PRE-BID CLARIFICATION FORM

PROJECT NAME:		FILLMORE HIGH SCHOOL NEW ATHLETIC COMPLEX	
PROJECT NUMBER:		Project No. 2024-017 / DSA #03-123950	
TO:		RJ Stump EMAIL: rj.stump@fillmoreusd.org Fillmore Unified School Dist. Roy Frey WestGroup Designs royf@westgroupdesigns.com	
DATE:	01/23/25		
FROM:	AMG & Associates, Inc David Silva 661-251-7401	EMAIL:	estimating@amgassociatesinc.com
DOCUMENT/DIVISION NUMBER:		DRAWING NUMBER:	20/S2-1.1

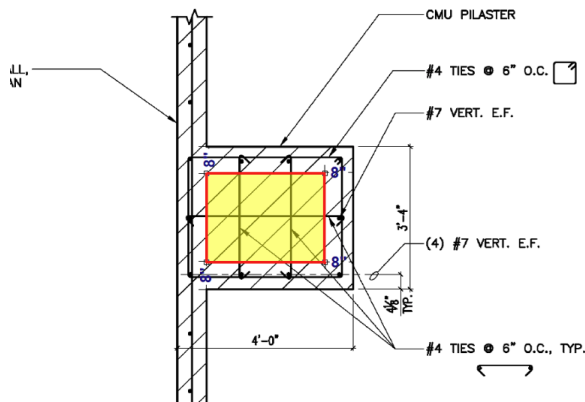
Per Detail 20 on Sheet S2-1.1 it is showing the 40"x40" CMU Pilaster condition. Please confirm if the intention is to grout solid the entire Center Void of the pilaster or if only the block surrounding the center void shall be solid grouted.

Correct.
